Proposed changes to TDECQ measurement process in 802.3bs clause 121.8.5

October 25, 2016

Proposed changes to TDECQ measurement process

TDECQ as the ratio of OMA/TX noise to scope noise is diminished

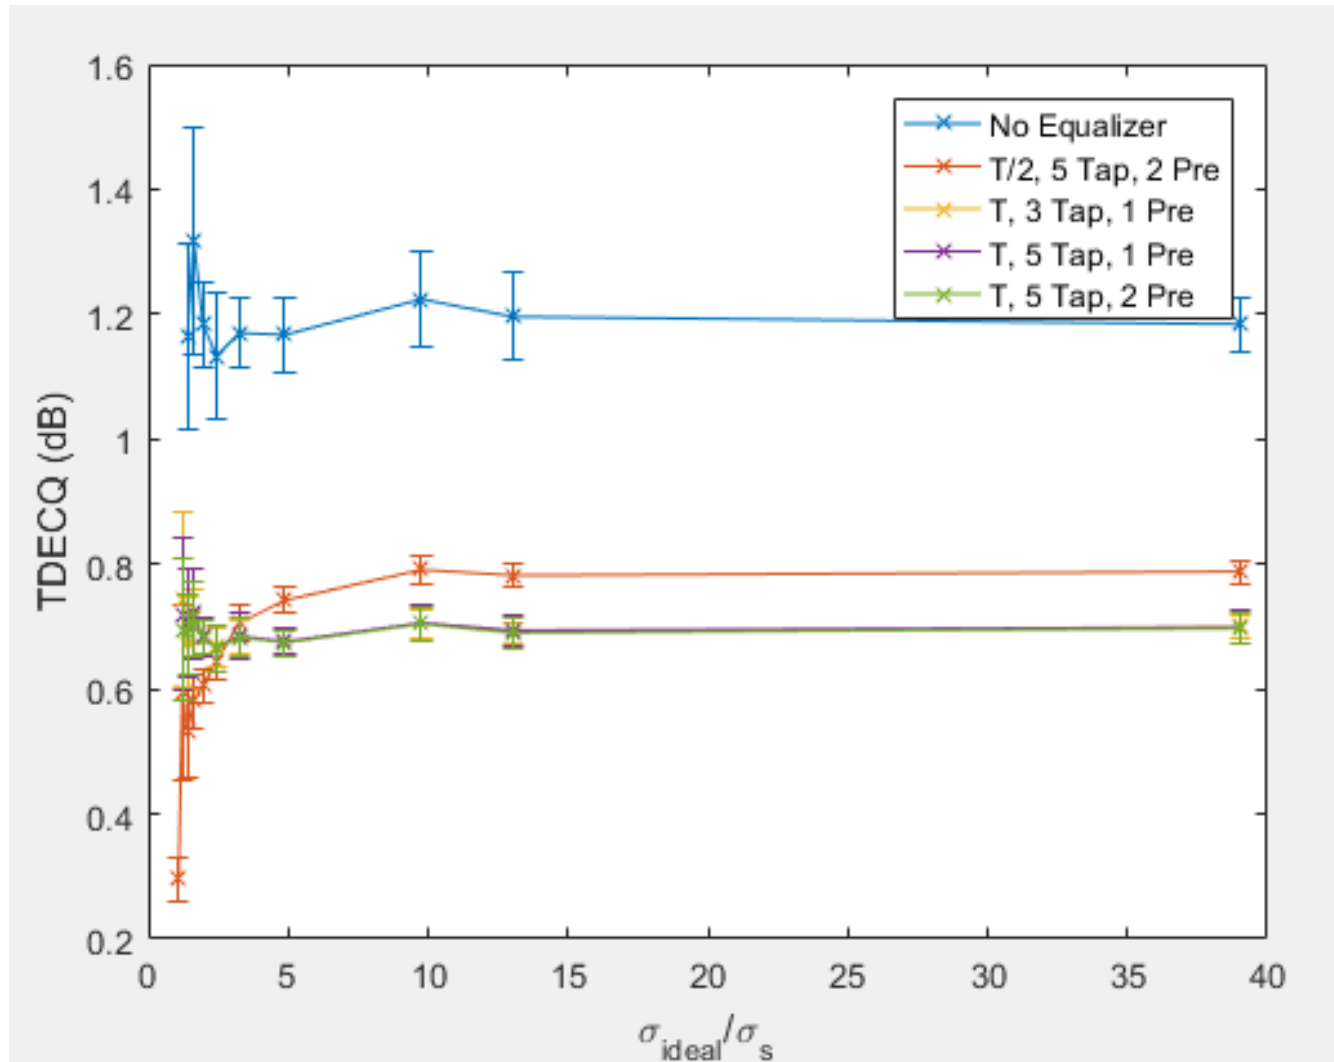
T/2 spaced equalizer can yield unanticipated results

- TDECQ is designed to back out the channel noise of the scope (σ_s). We would expect that for a fixed OMA and Tx signal noise, that TDECQ would be constant as σ_s is varied
- We can see that as the intrinsic noise begins to dominate the signal, the T/2 equalizer optimizes for noise reduction, which produces smaller TDECQ numbers. The TDECQ number is affected similarly when the scope noise is increased, but it serves to slow the increase in TDECQ that is expected

When scope noise is proportionally large T/2 equalizer optimizes to diminish scope noise and yield a low TDECQ result. Not seen with T spaced implementation

T spaced design edits

- **Section 121.8.5.4, pg227, line 27:**
- Change: ...is a 5 tap, $T/2$ spaced, feed-forward equalizer (FFE), where T is the symbol period.
- To: is a 5 tap, 1 precursor, T spaced, feed-forward equalizer (FFE), where T is the symbol period.
